OAKLAND COUNTY SECURITY STUDY JSP17-47

Consideration at the request of Giffels Webster on behalf of 52-1 District Court for Preliminary Site Plan and Stormwater Management Plan approval. The subject parcel is located in Section 17, west of Beck Road and south of Twelve Mile Road. It is approximately 4.73 acres and zoned OSC (Office Service Commercial). The applicant is proposing a fence with limited access gates surrounding the building and employee parking, retaining wall cut into the berm along Grand River Avenue, and additional employee parking spaces to the north of the building.

PLANNING REVIEW

Date:	05.08.2017
Scale:	1"=30'
Sheet:	C550.1
Project:	18833.60

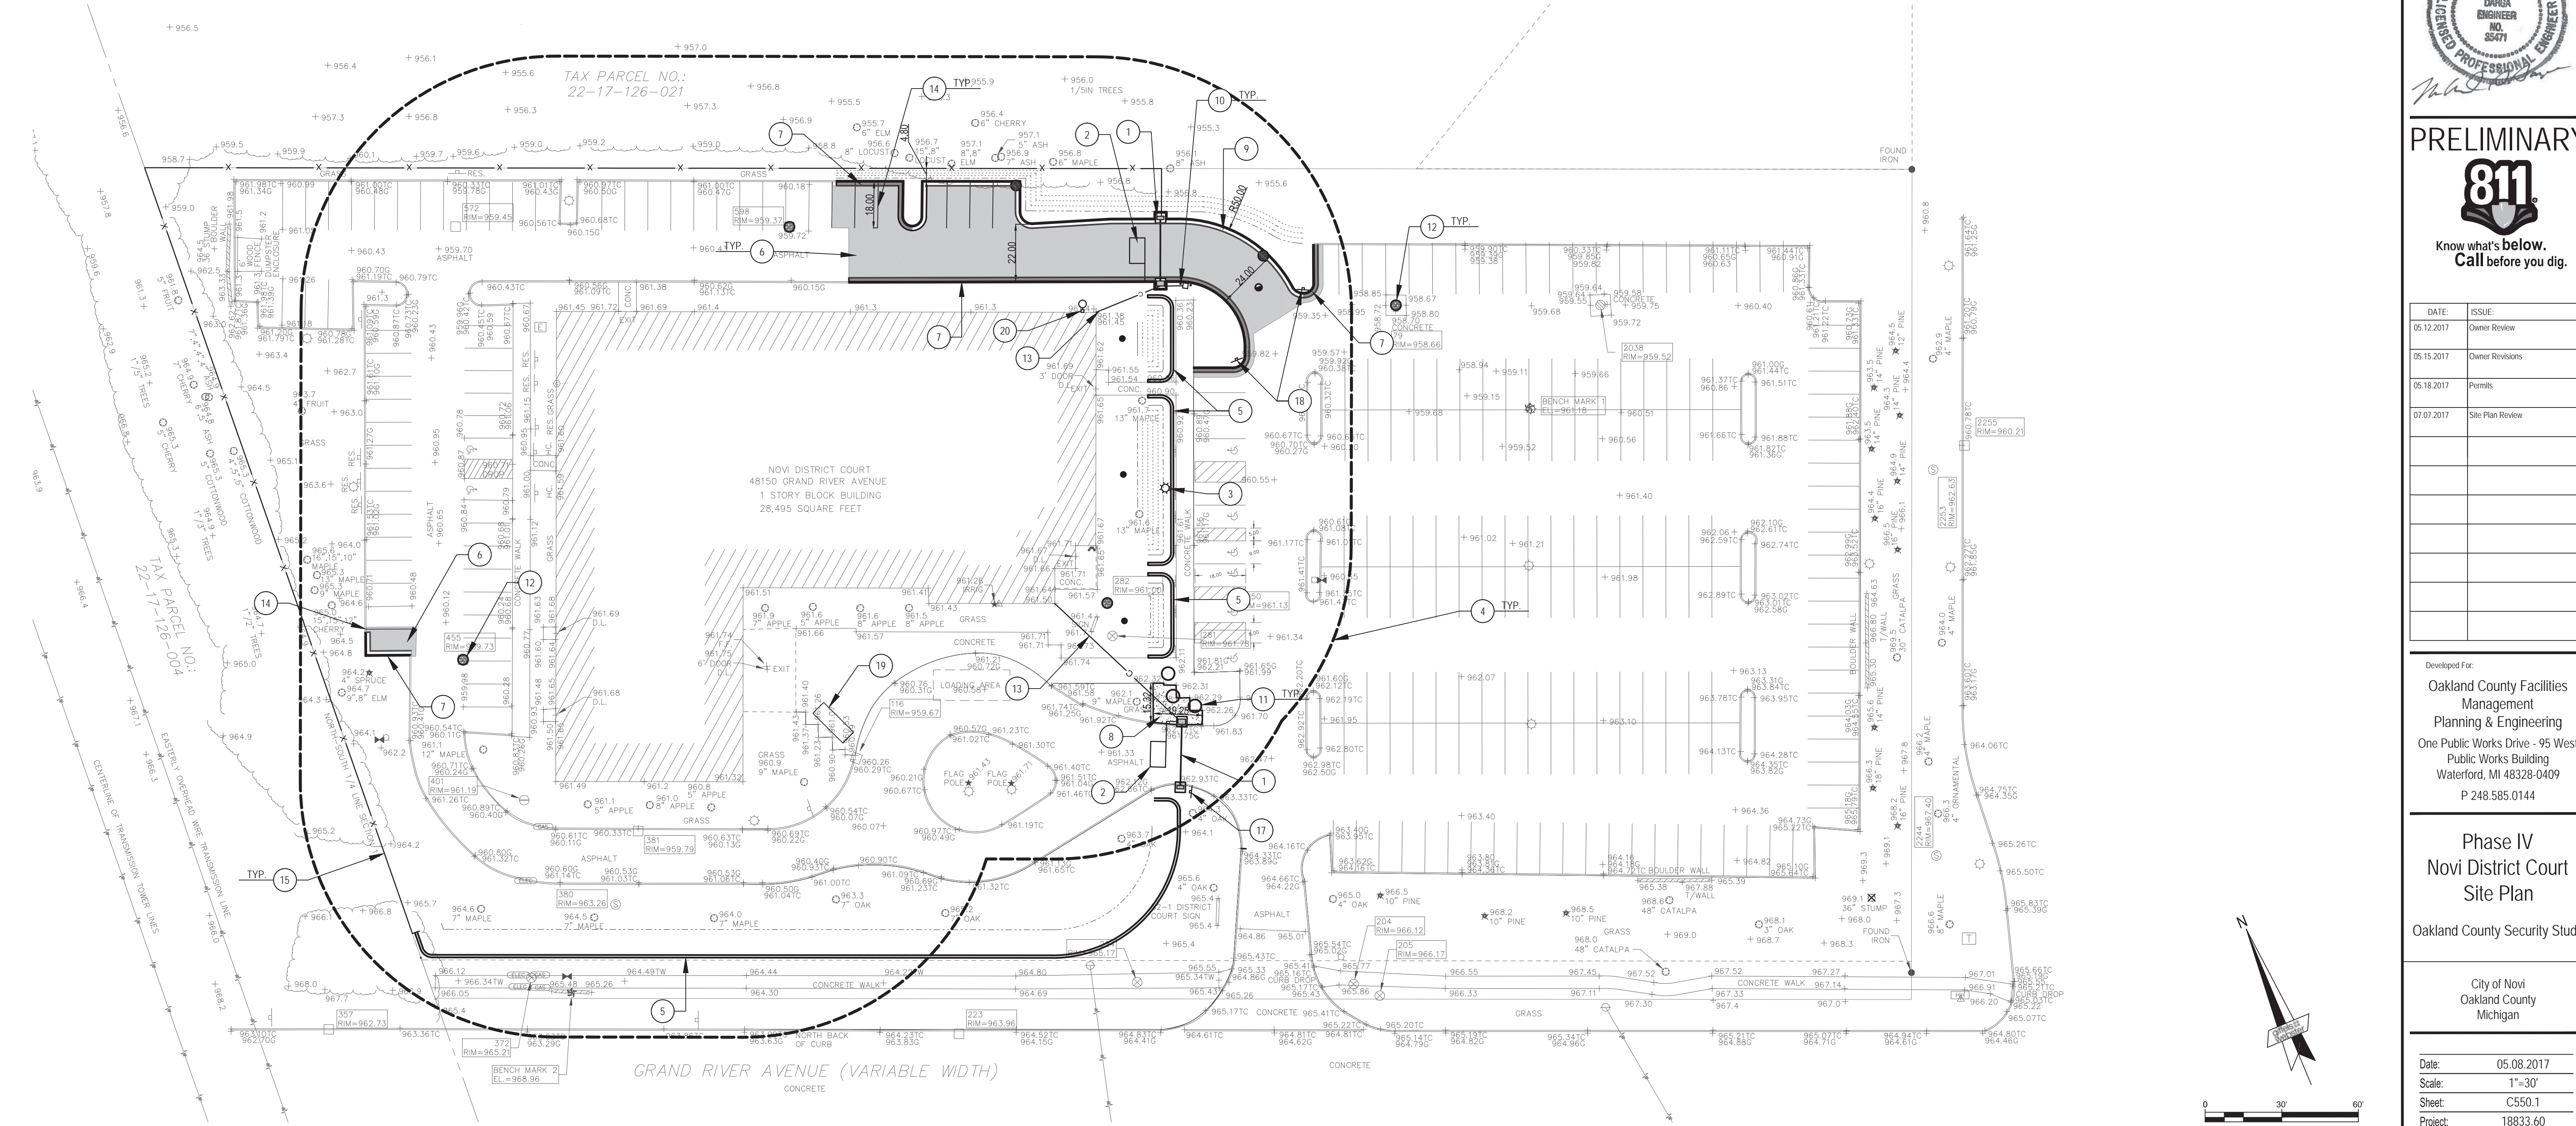
3. Parking Space Dimensions (Sec. 5.3.2): **Provide measurements on plans of the new parking spaces.**
4. End Islands (Sec. 5.3.12): **Provide measurements on the site plan that show the end island and landscape island dimensions.**

5. Bicycle Parking General Requirements and Lot Layout (Sec. 5.16): **Provide dimensions of proposed bike rack location and spacing.**
6. Fences (Sec. 5.11): The applicant is proposing a fence surrounding the building and connected to the proposed berm/retaining wall. While, not on the plans the applicant has stated that the height of the new fence will be 5 ft., which is under the 8 ft. maximum. **Please show on the site plan the height of the fence and height on the detail sheet.** The location of the fence is within the front yard, which is not allowed in non-residential districts. **The applicant should see a ZBA variance for the location.**

- c. The word "Authorized" has a typo in Note 18 on Sheet 550.1
 - d. While sign post sizing is in compliance with City standards, the City also requires that the sign post be U-channel in shape. Please indicate on the plans that all sign posts are U-channel posts.

- e. Sign post information provided in the notes section of Sheet C550.1 is in compliance with City standards; however, the callout for the post sizing on the parking signage detail on Sheet 800.1 differs from the notes and should be corrected to be in compliance with City standards.

Date:	05.08.2017
Scale:	1"=30'
Sheet:	C651.1
Project:	18833.60

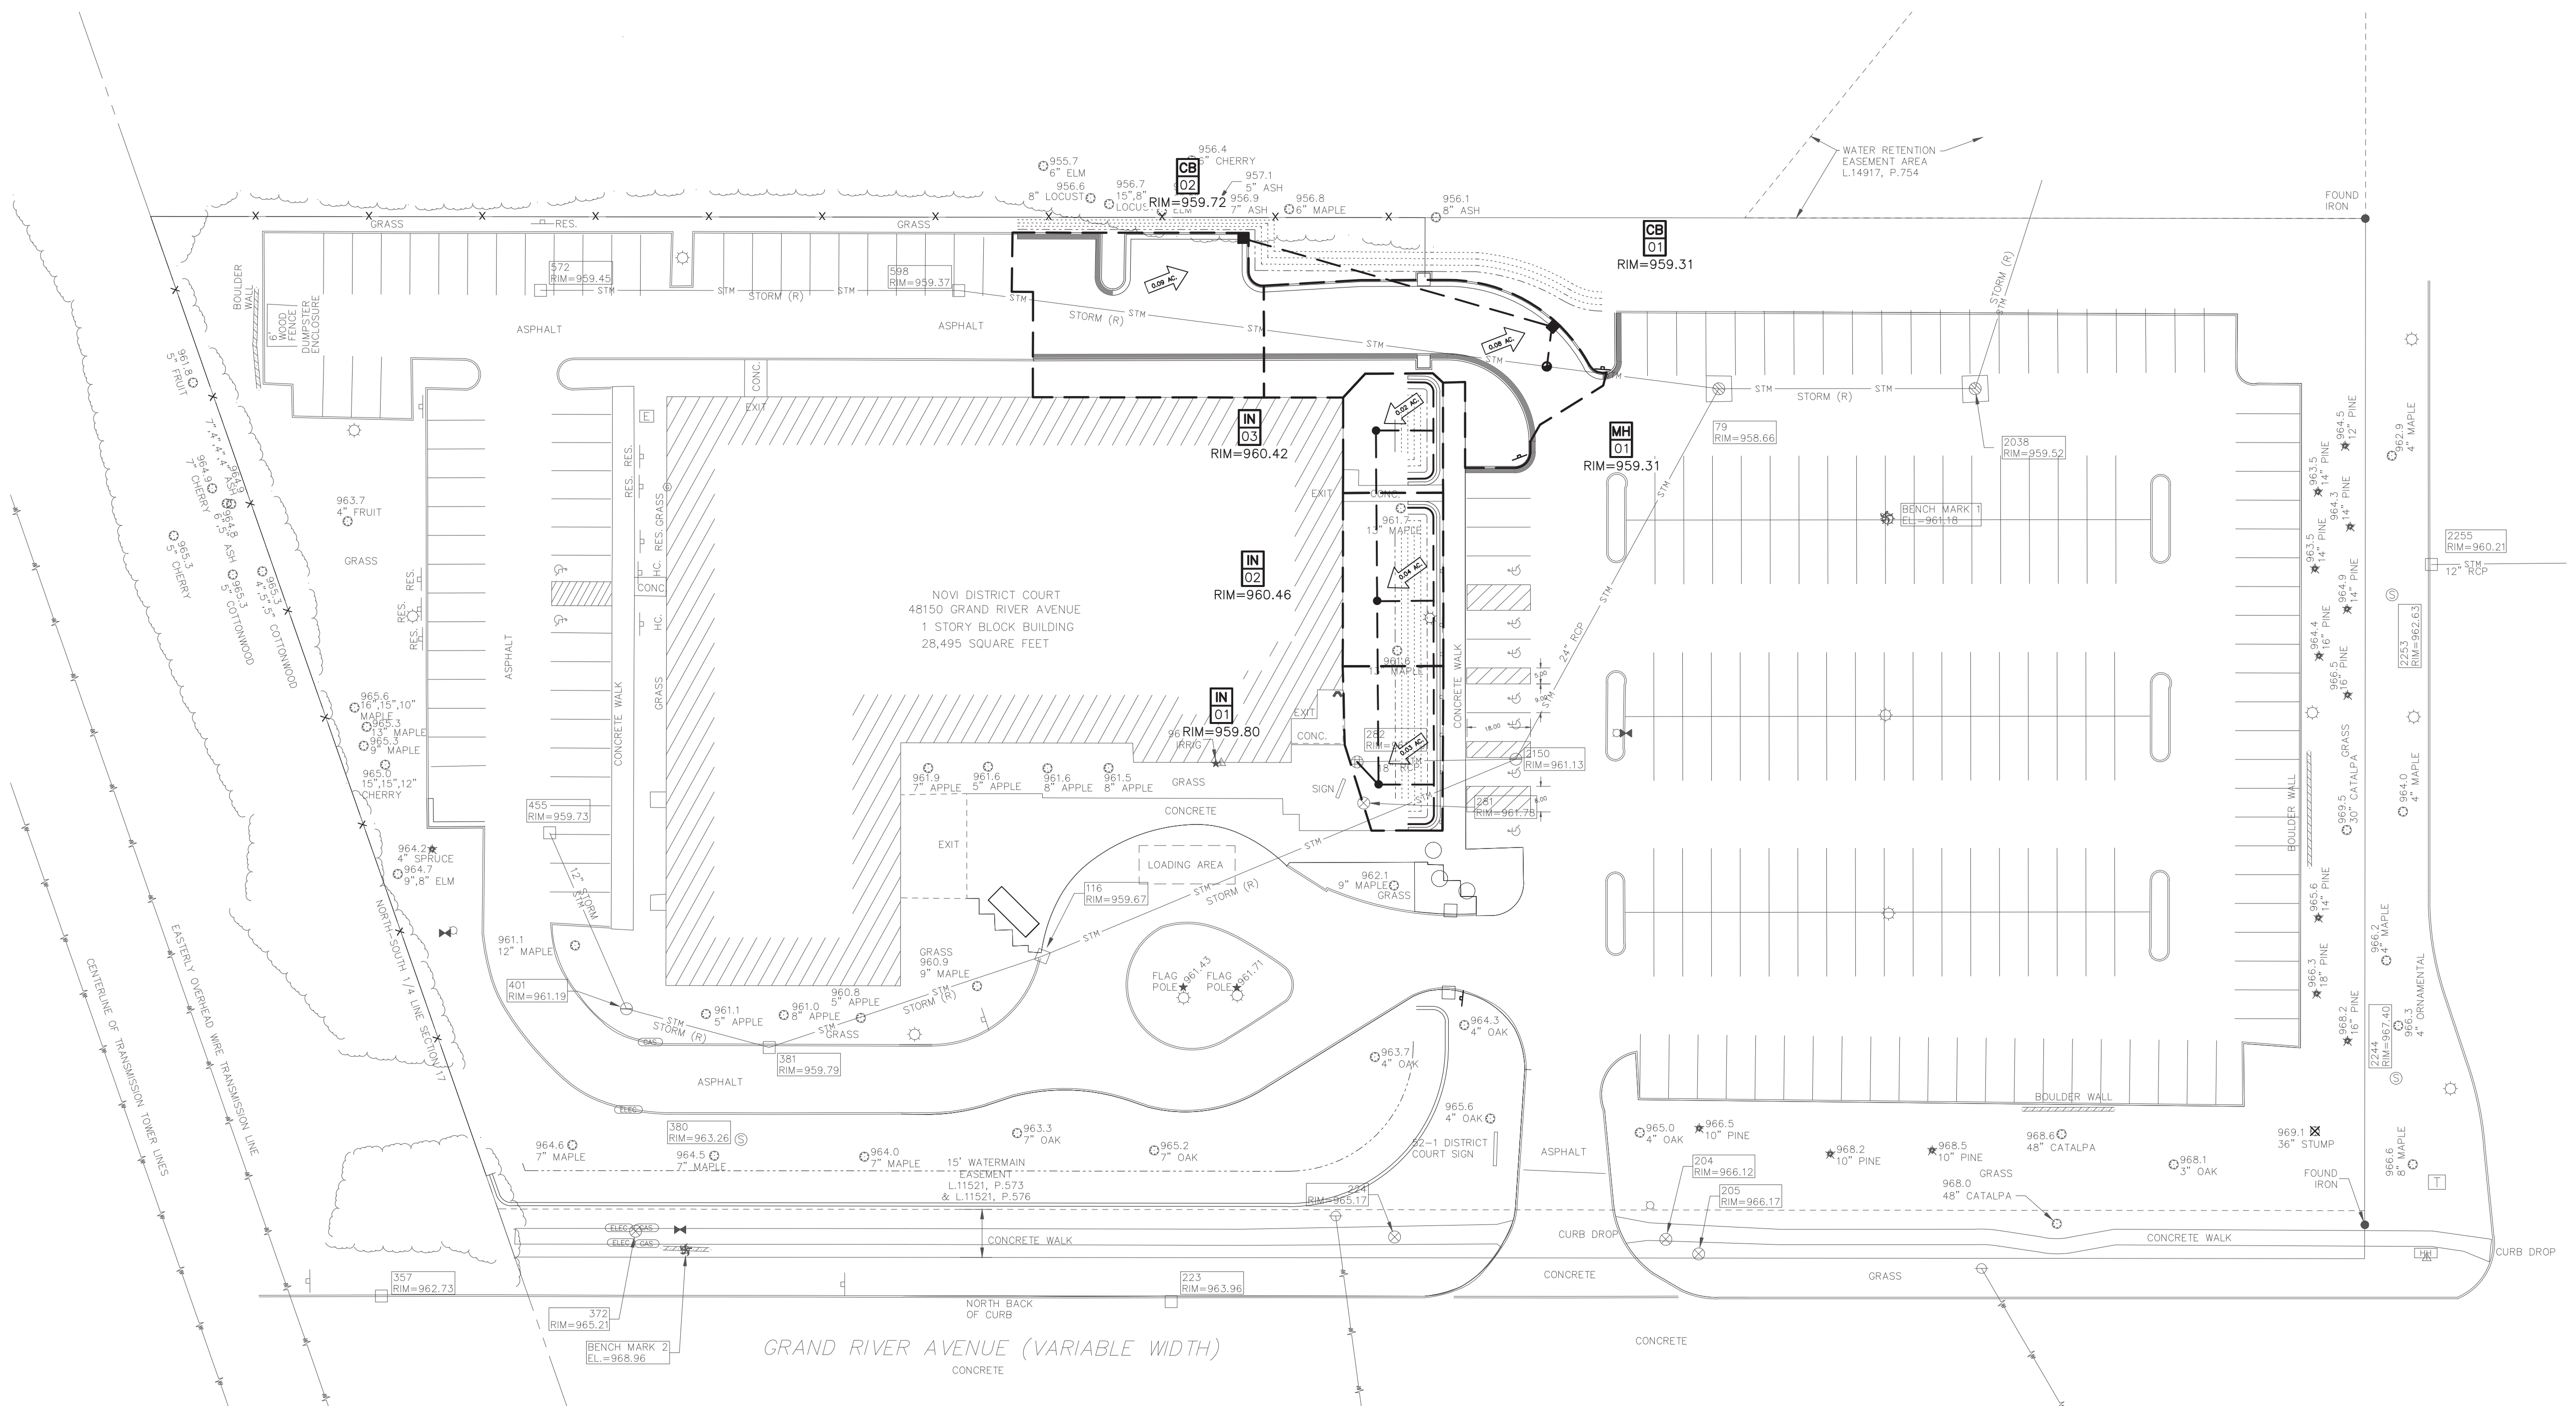
4. Provide a storm water mechanical treatment structure.
5. Include notes and details of the required maintenance for the storm water mechanical unit.
6. A Storm Drainage Facility Maintenance Agreement is required for the mechanical unit. The current template of the City's Storm Drainage Facility Maintenance Agreement can be found on the City's website and a complete draft shall be provided at the time of Stamping Set submittal.

7. Provide profiles of all storm sewer 12 inch and larger. Illustrate all pipes intersecting storm structures on the storm profiles.
8. Label the 10-year HGL on the storm sewer profiles, and ensure the HGL remains at least 1-foot below the rim of each structure.

9. Provide a schedule listing the casting type and other relevant information for each proposed storm structure on the utility plan. Round castings shall be provided on all catch basins except curb inlet structures.

Date: 05.08.2017
Scale: 1"=30'
Sheet: L550.1
Project: 18833.60

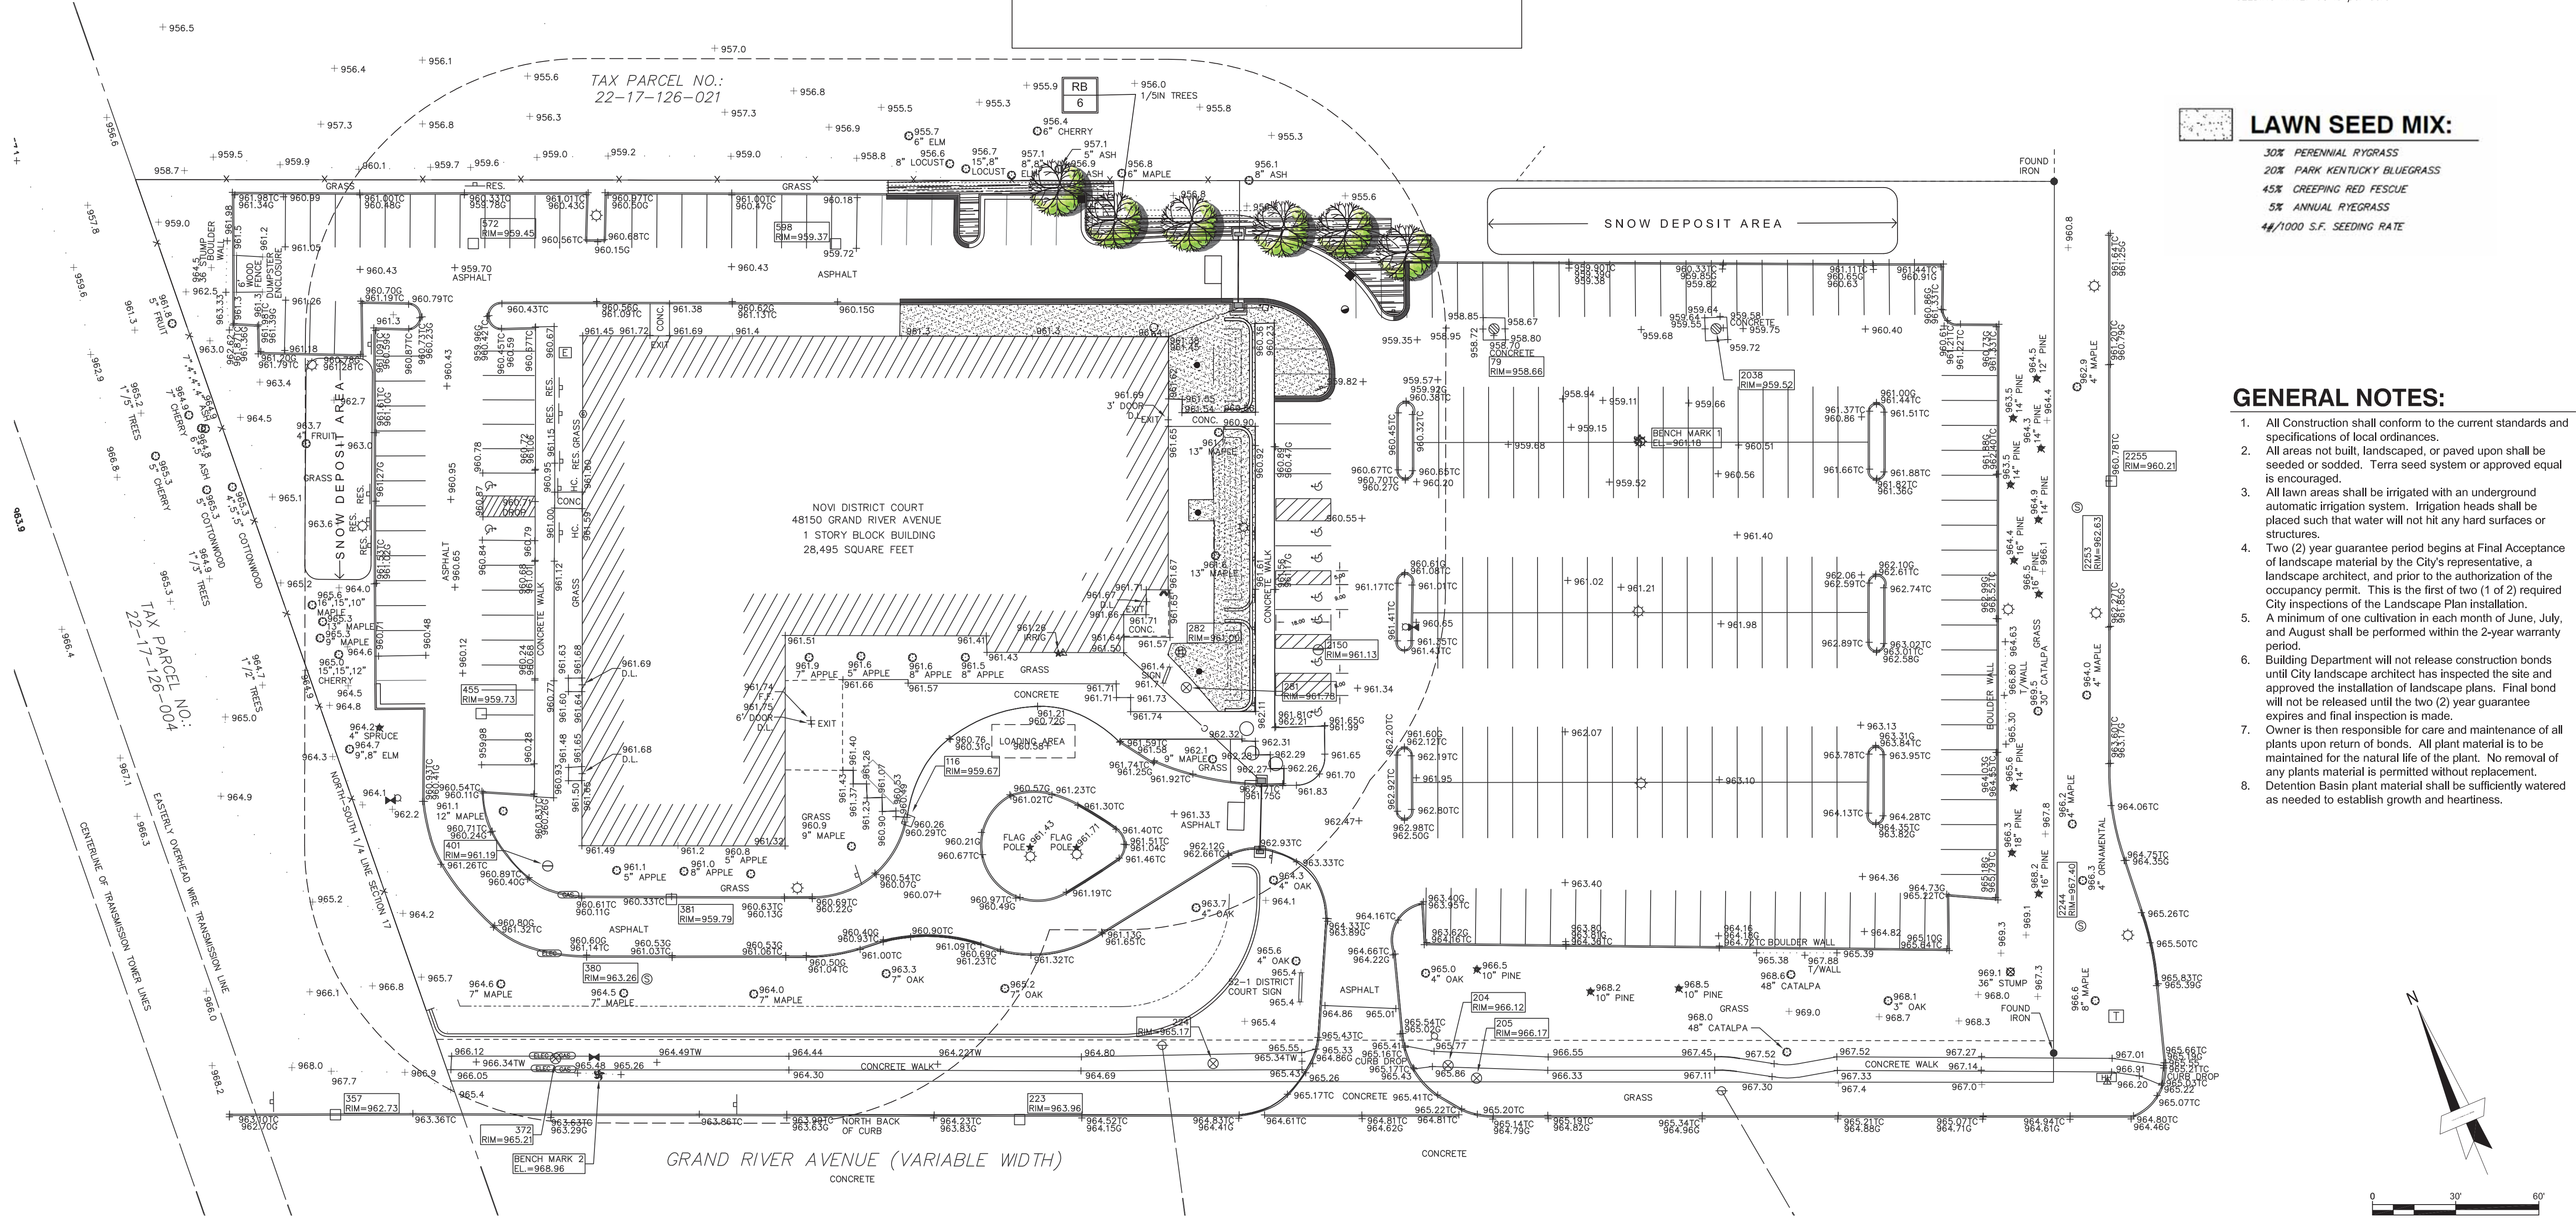
1. The island required to break up the 19 space parking bay has been provided.
2. **Please expand the island's width to at least 10 feet and its area to at least 200 sf, and plant one of the perimeter trees within it.**

1. Based on the perimeter noted, 6 perimeter trees are required and are provided. As noted above, one should be placed within the new island to help break up the visual expanse of parking.
2. **Please plant 2 of the other perimeter trees in the new islands formed at the start of the new entry to help shade the existing parking lot.**

1. All but the tree protection fencing detail have been provided. **Please add that to the demolition plan.**
2. **Please do not include Birds Foot trefoil in the steep slope mix as it is quite invasive.**
